# HISTORIC AND DESIGN REVIEW COMMISSION

**HDRC CASE NO:** 2017-278  
**ADDRESS:** 701 EVERGREEN CT  
**LEGAL DESCRIPTION:** NCB 399 BLK 27 LOT 12A  
**ZONING:** R-6 H  
**CITY COUNCIL DIST.:** 1  
**DISTRICT:** Tobin Hill Historic District  
**APPLICANT:** Geoffrey Myane  
**OWNER:** Geoffrey Myane  
**TYPE OF WORK:** Demolition of rear accessory structure, exterior modifications, construction of 1-story rear addition

## REQUEST:

REMODEL REAR EXTERIOR ELEVATION

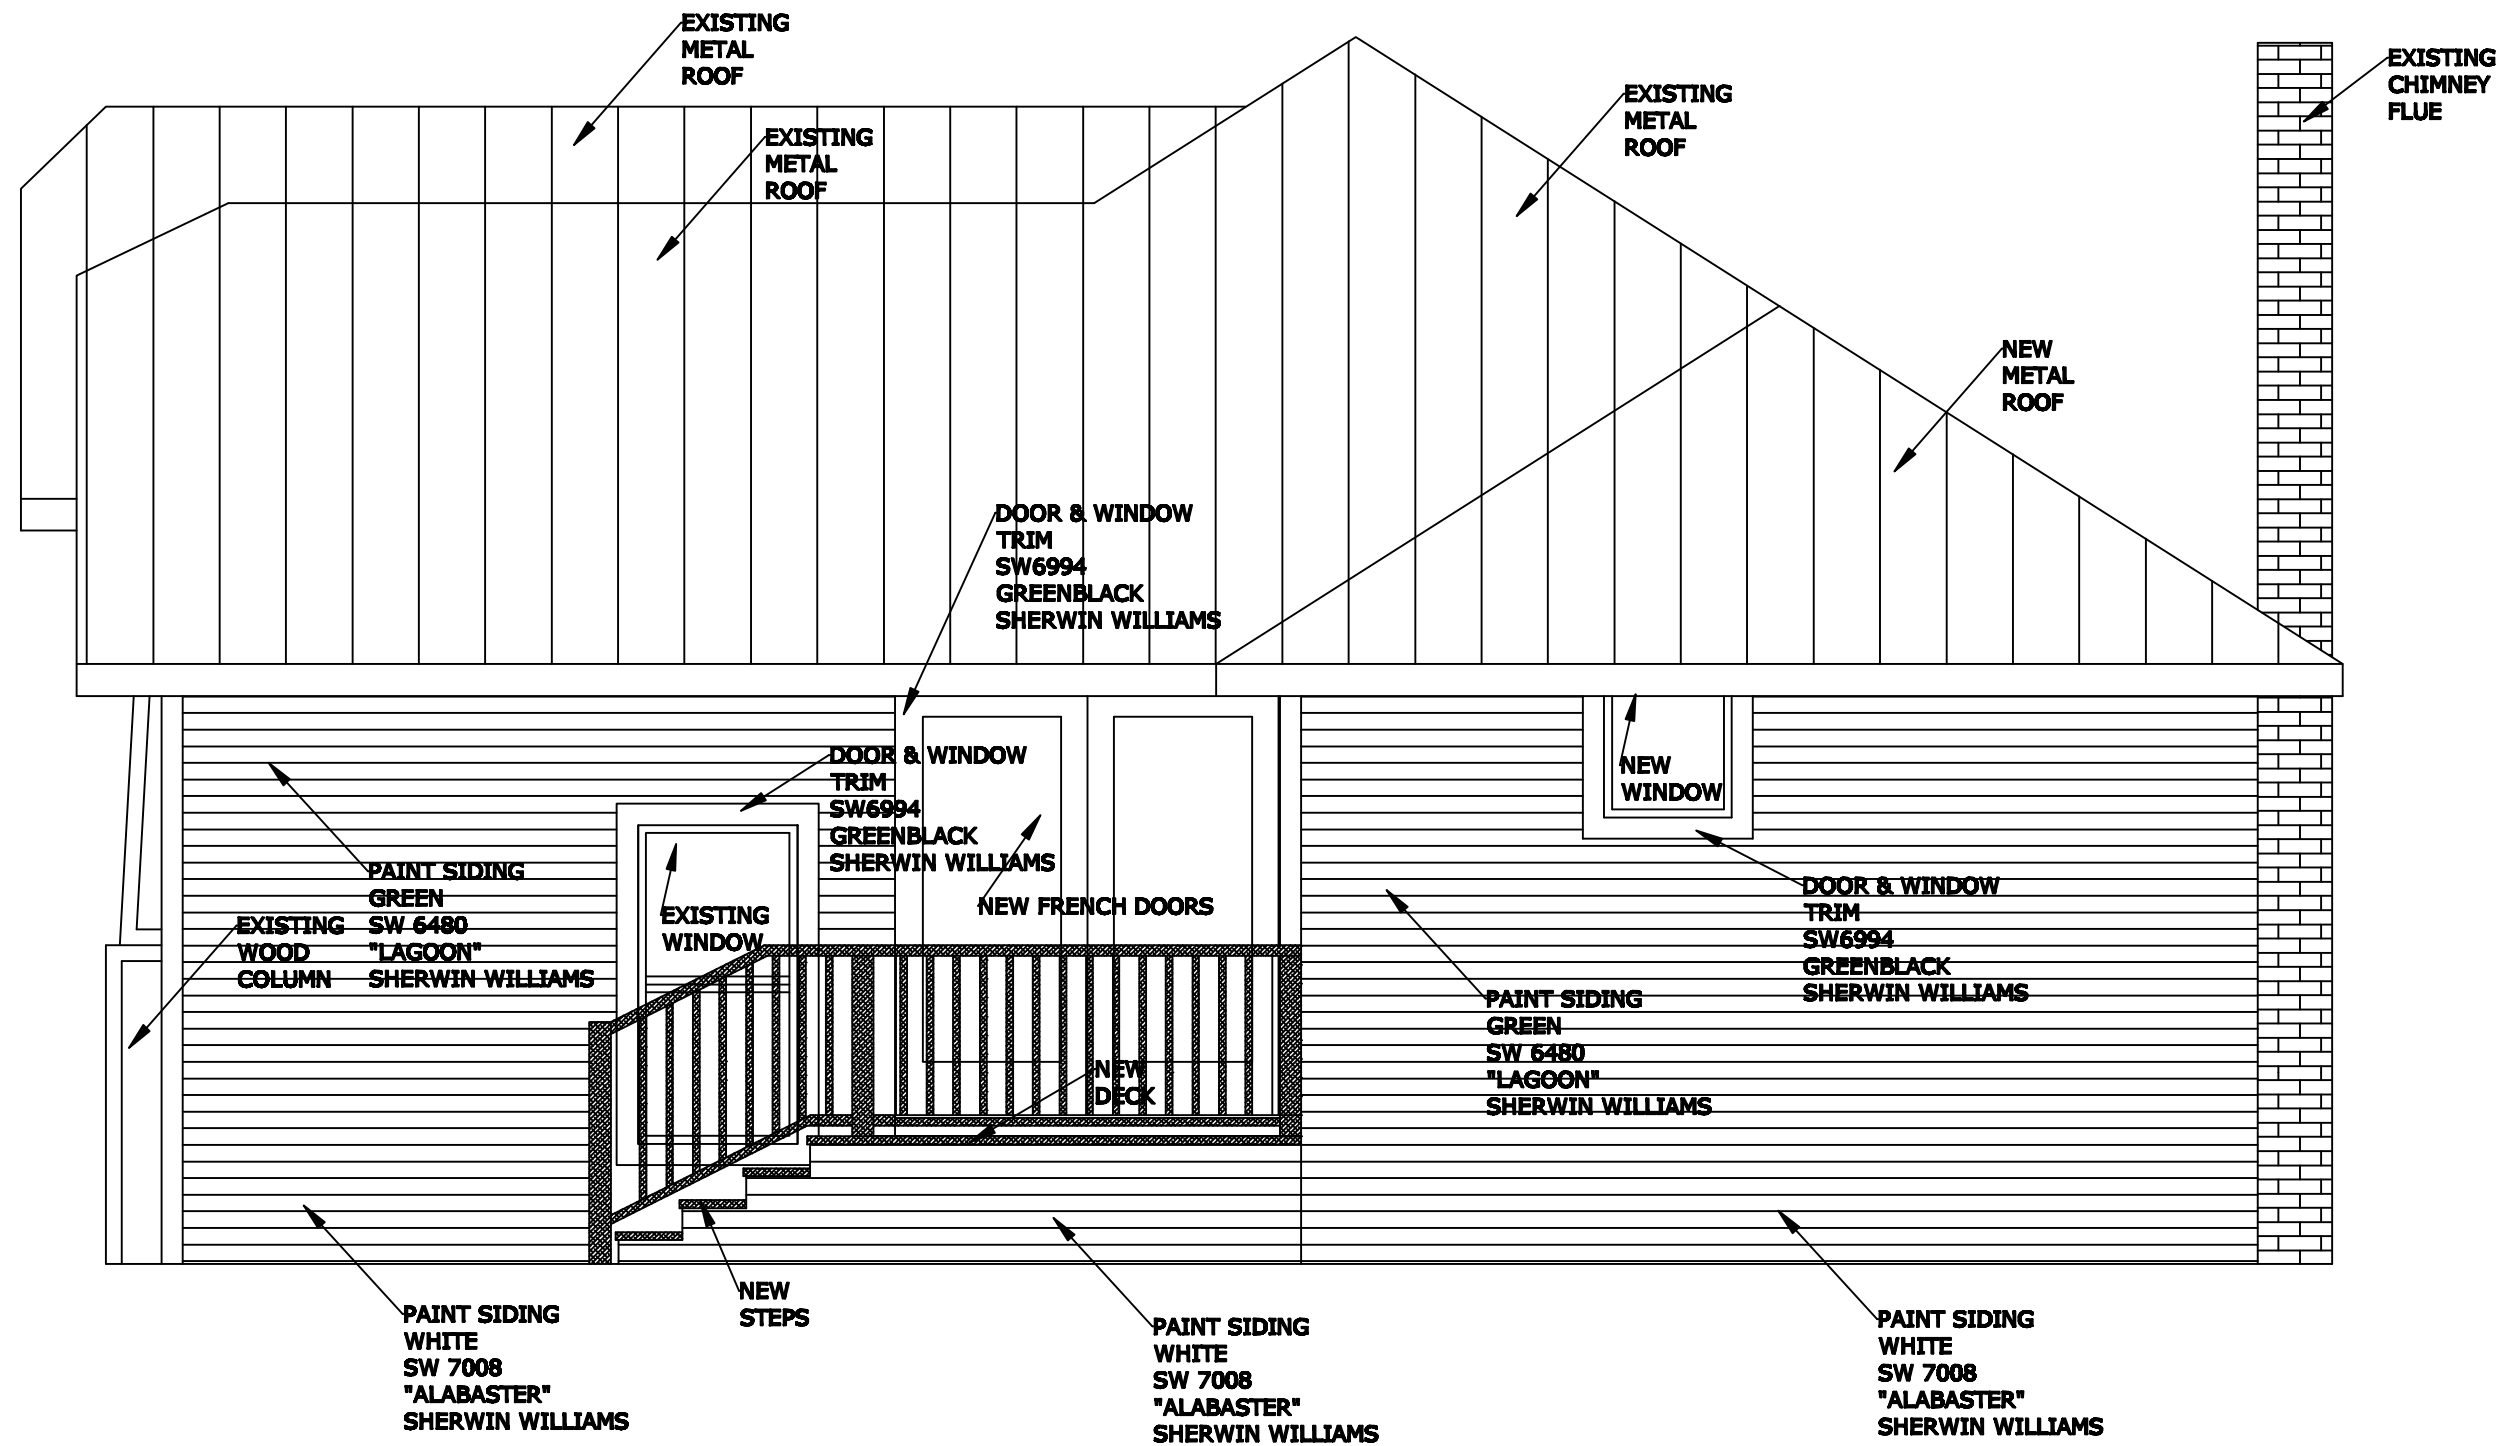
- REAR WINDOW AND DOOR REMOVAL** – The proposed addition will require the removal of four existing one over one wood windows. According to Guideline 6.A.i, filling in historic openings should be avoided, especially when viewable from the public right-of-way. These elements are not visible from the public right-of-way. Guideline 3.C.i in the Historic Design Guidelines for Additions encourages the salvage and reuse of historic materials, where possible, that will be covered or removed as a result of an addition. Staff finds the proposal

- l. REAR STAIRS AND RAILING – The applicant has proposed to construct a new covered deck with stairs and railing on the rear of the proposed addition. According to Guideline 7.B.iv for Exterior Maintenance and Alterations, added porch elements, such as stairs and railings, should be simple as to not distract from the historic character of the building. The proposed railings and columns appear generally compatible with the style and materiality of the home, but staff has not seen dimensioned drawings that indicate the height of the proposed railing, the treatment of the decking or steps, or the size and configuration of the railing elements.

- iv. That the applicant submits plans and elevations that indicate the dimensions of the proposed rear covered deck stairs and railing elements to staff for approval.

NEW ROOF PLAN W/ NEW ADDITION

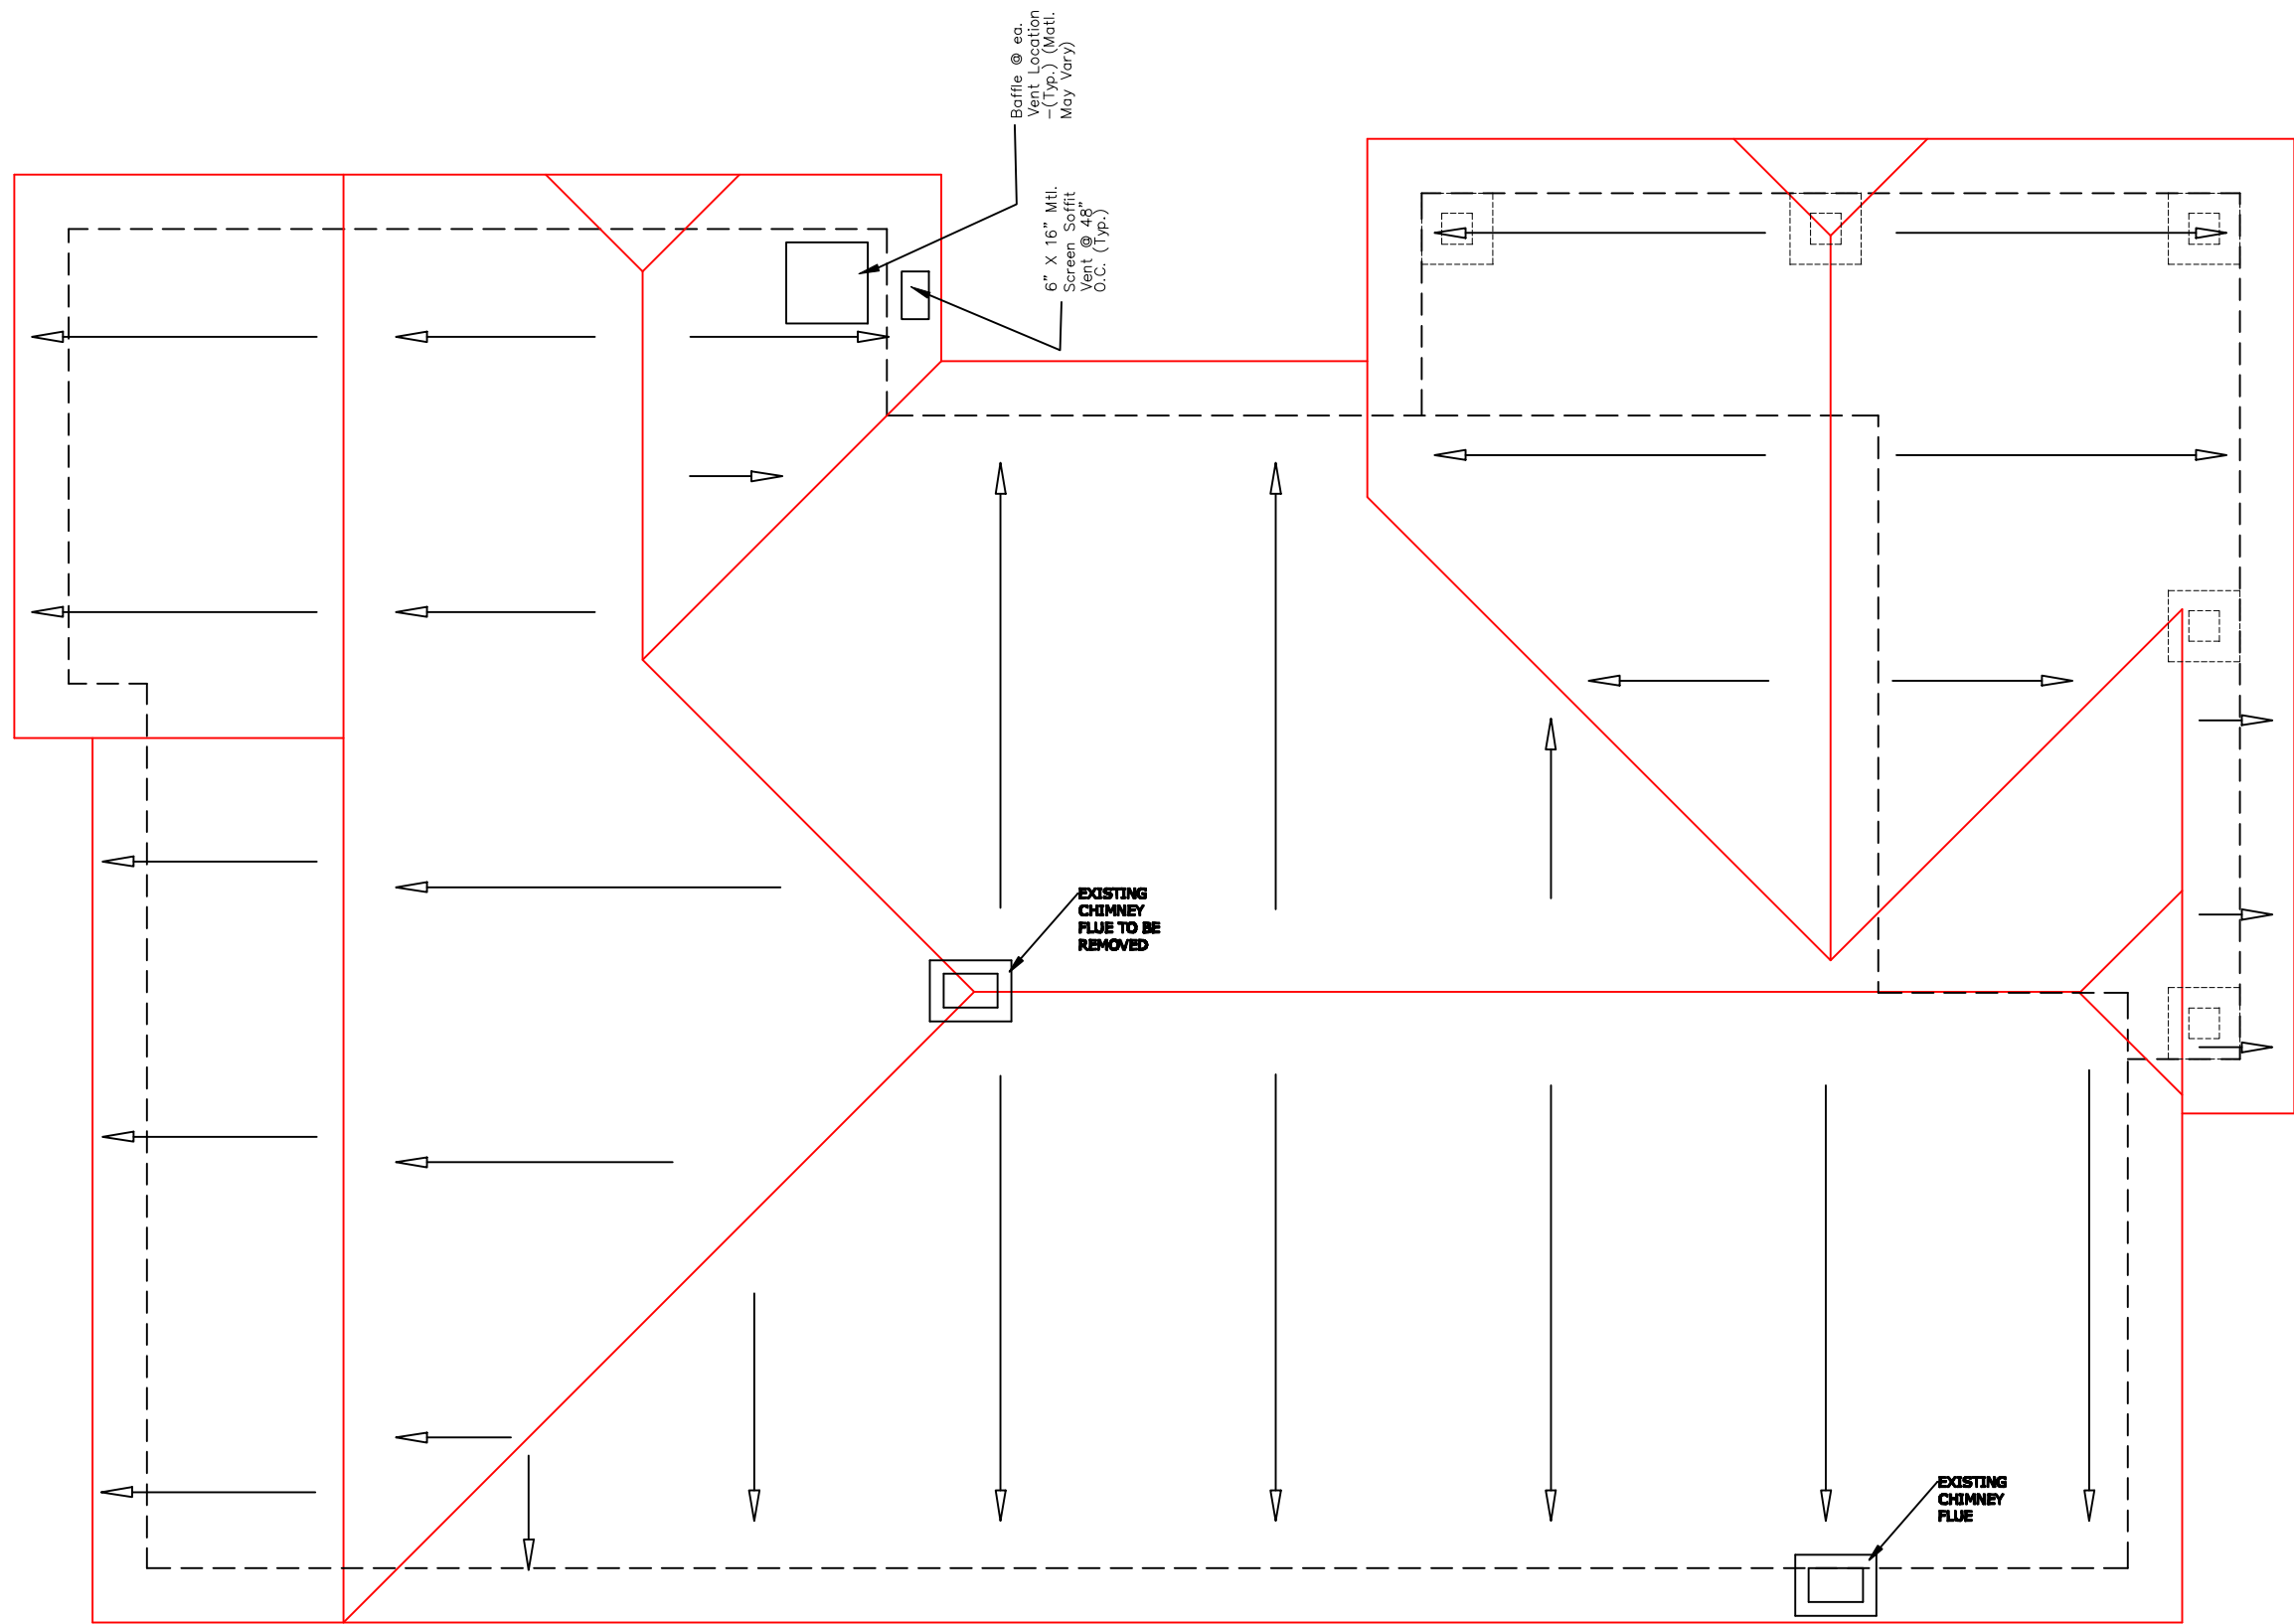
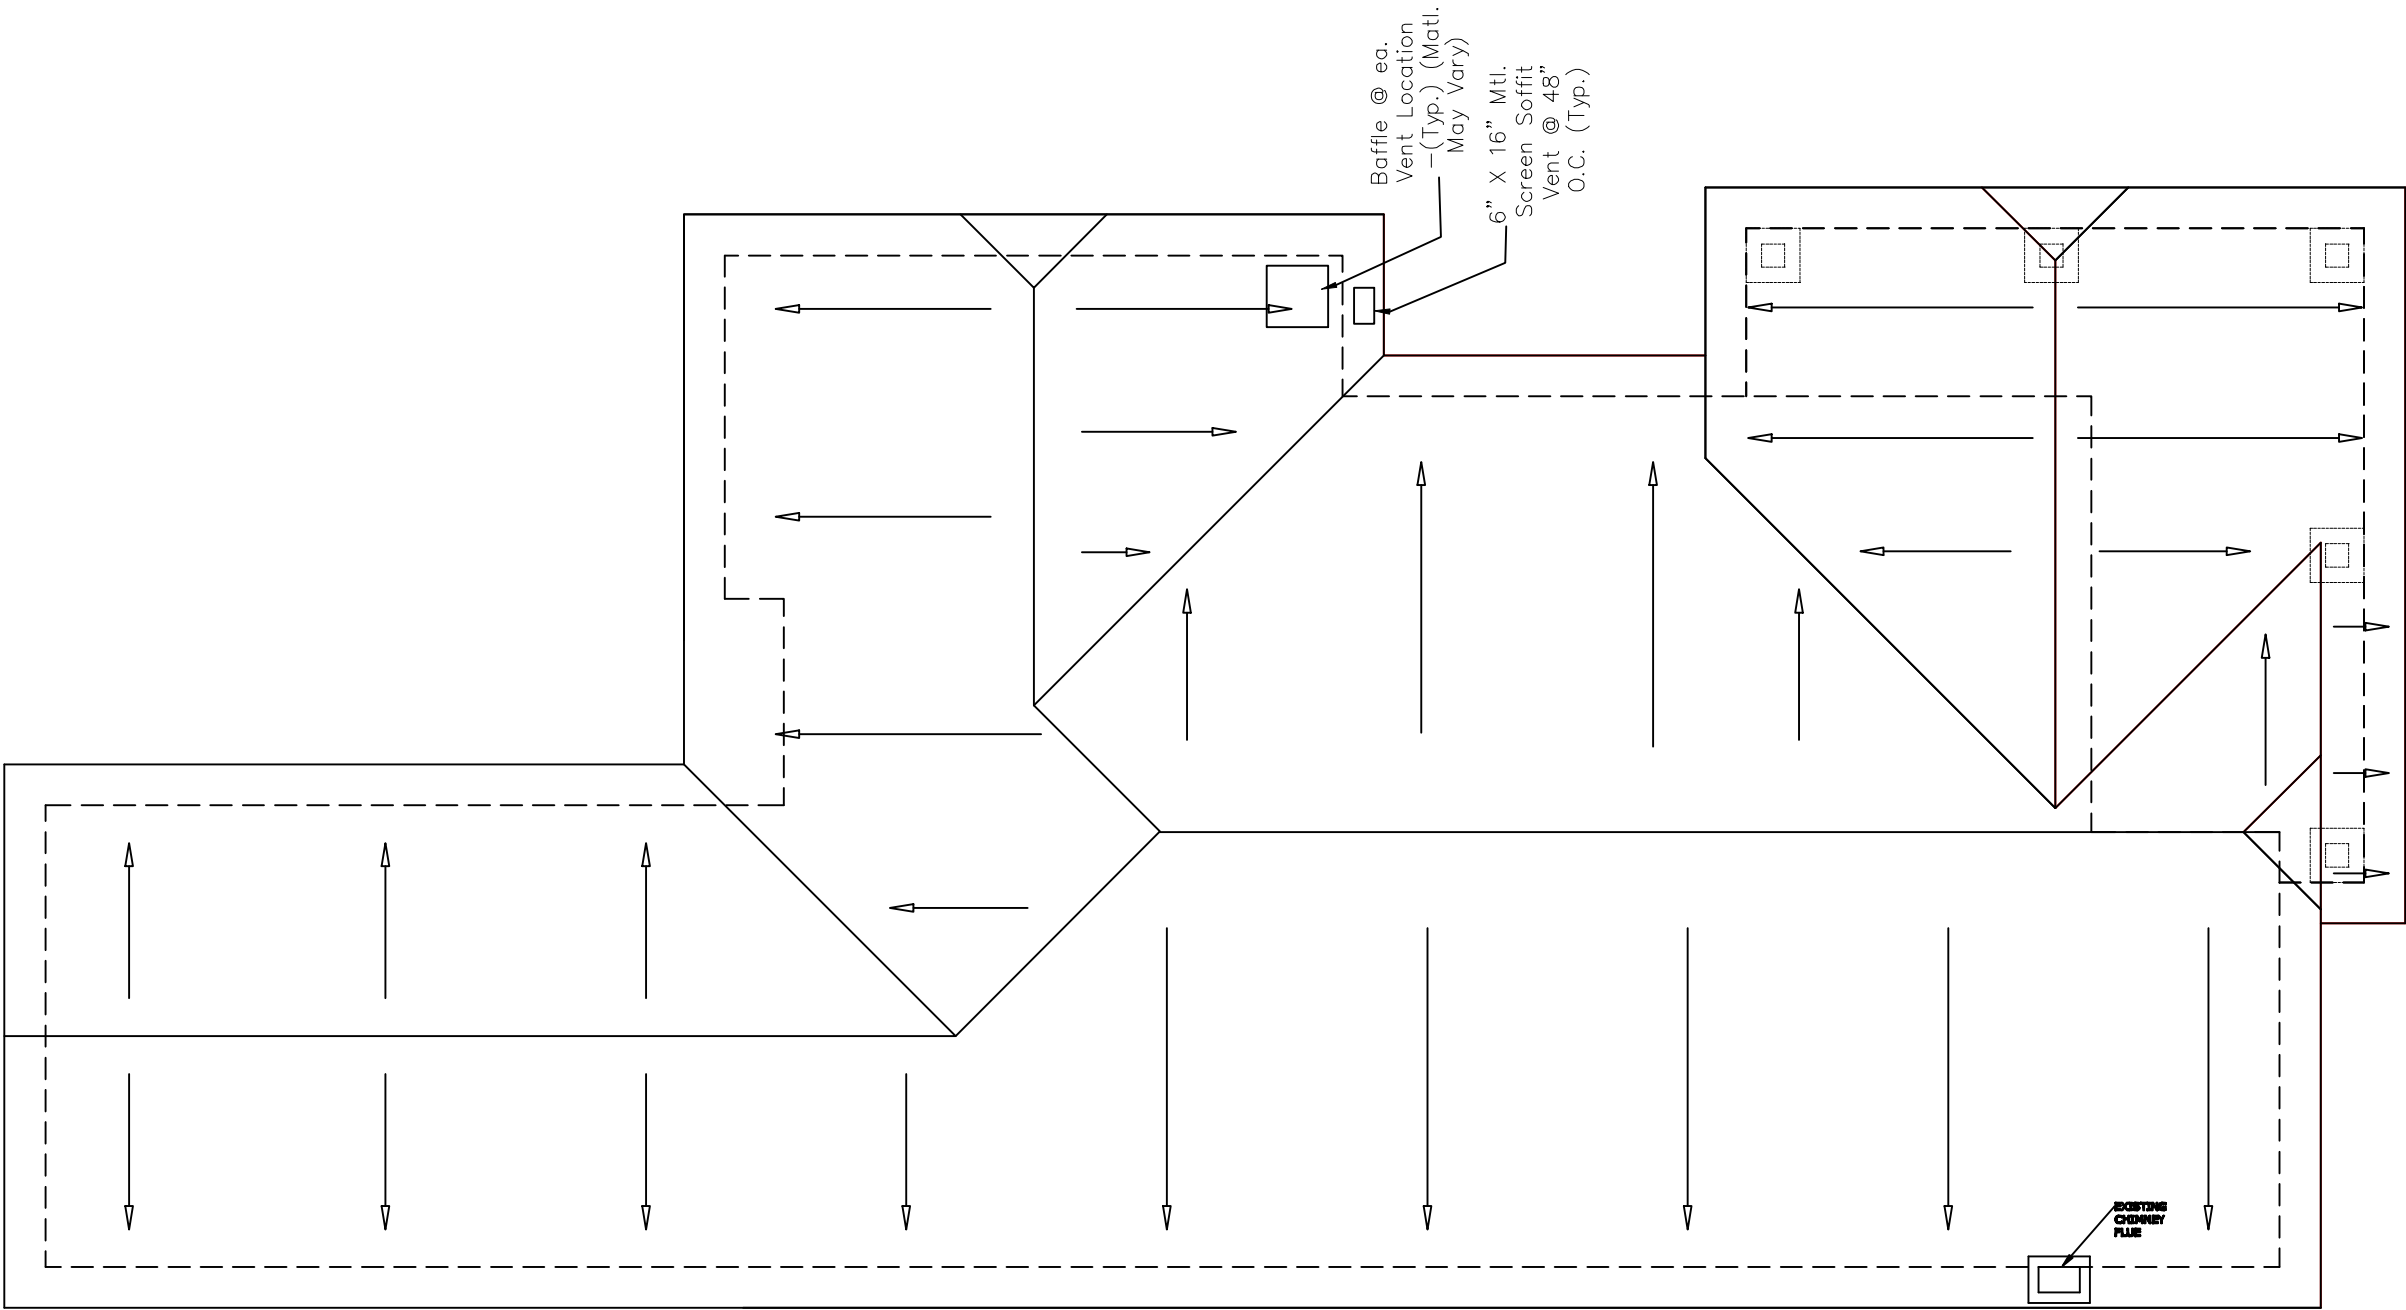
- ROOF** – The proposed addition is 1-story in height and is subordinate to the existing roofline of the primary structure. The proposed addition will modify the existing rear roofline to accommodate the new addition. The modification adjusts the rear ridgeline slightly and creates a new hipped roof over the proposed addition. The Historic Design Guidelines for Additions state that new additions should utilize a similar roof pitch, form, and orientation as the principal structure. Staff finds the proposed roof form consistent with the Guidelines.

- ROOF MATERIAL** – The existing roofing material on the primary structure is a standing seam metal roof. The applicant has proposed to install a new standing seam metal roof to closely match the existing structure. Staff finds the proposal consistent with the Guidelines.
